# Injection Apertures in IP2 and IP8: VCTY Problem

# VCTYB chamber

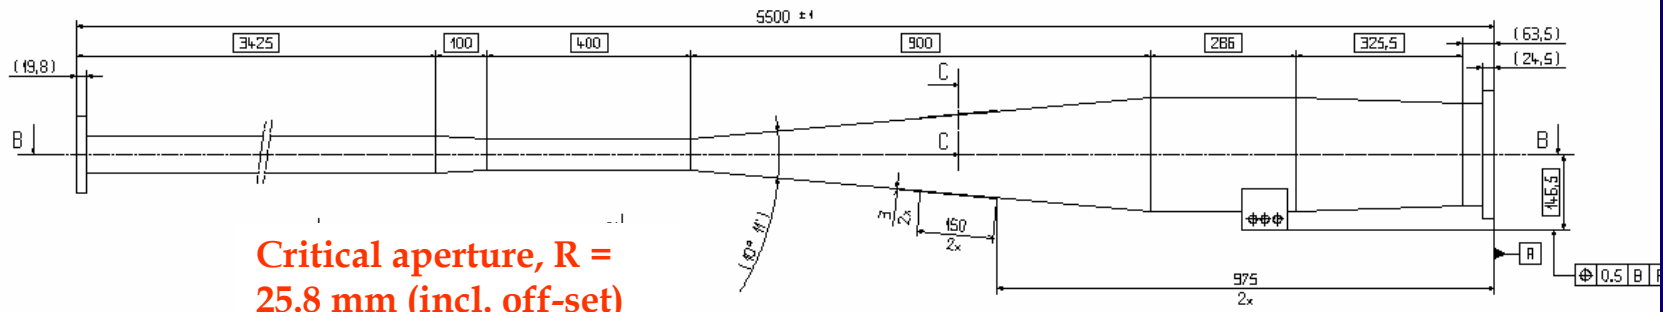
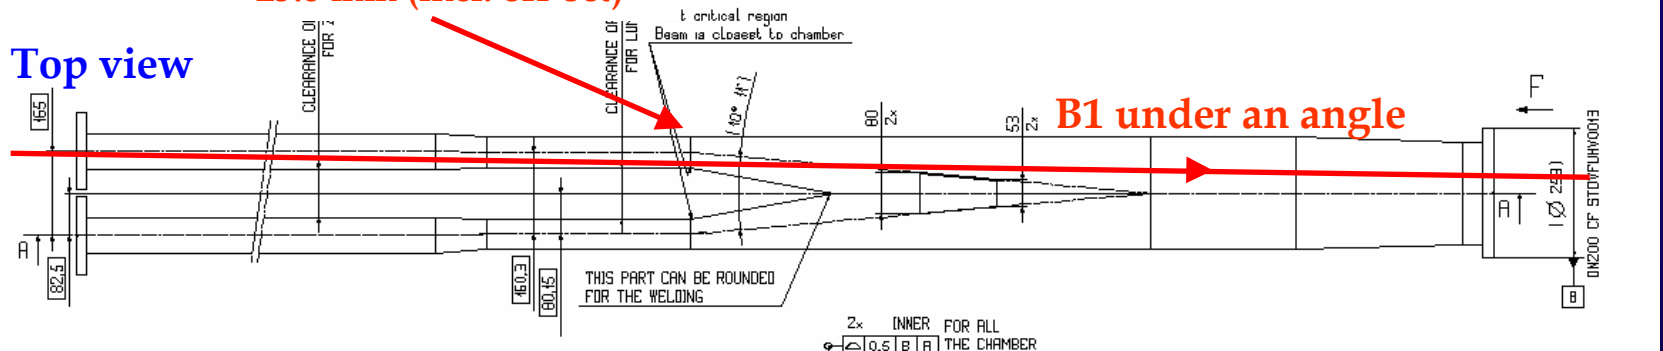
Critical aperture,  $R = 25.8$  mm (incl. off-set)

Calculations for optics V6.500  
Injection onto bumps / separation

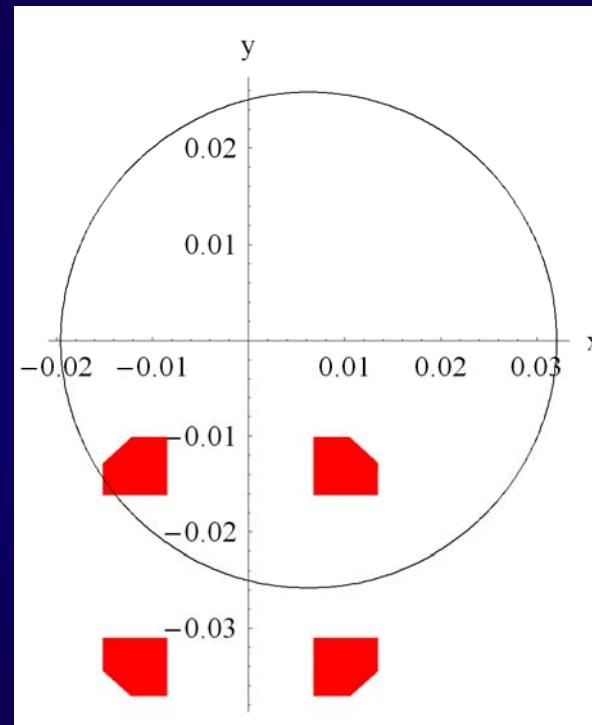
Normally stored beam is ok.  
Large effective off-set of vacuum  
chamber rel. to the beam

Stored beam kicked by injection  
kicker: missing aperture about  
15 mm

Normally injected

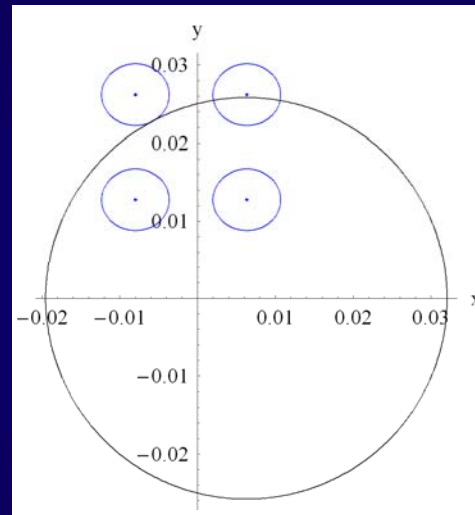
*Need to add 4 mm more vertical aperture if V-crossing changes sign*

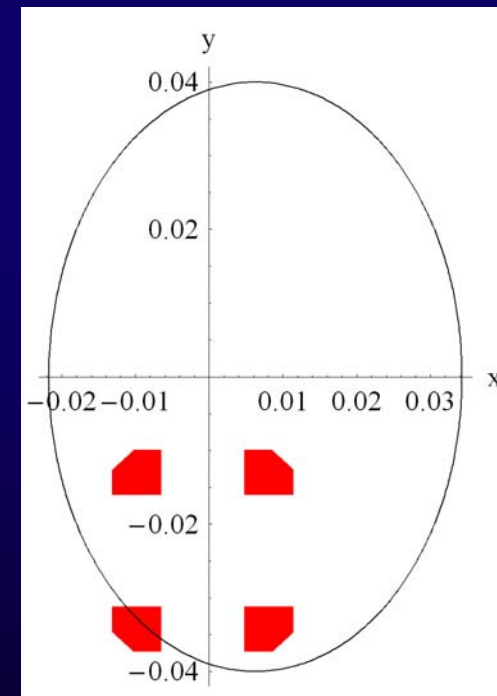
Enlarged chamber ellipse of 28 mm x 40 mm, 2 mm closed orbit,  $n_1 = 7$ : still seems to be a bit tight.

Acceptable, or can it be a bit larger?

What is the constraint?

*... check injected on different orbit...*
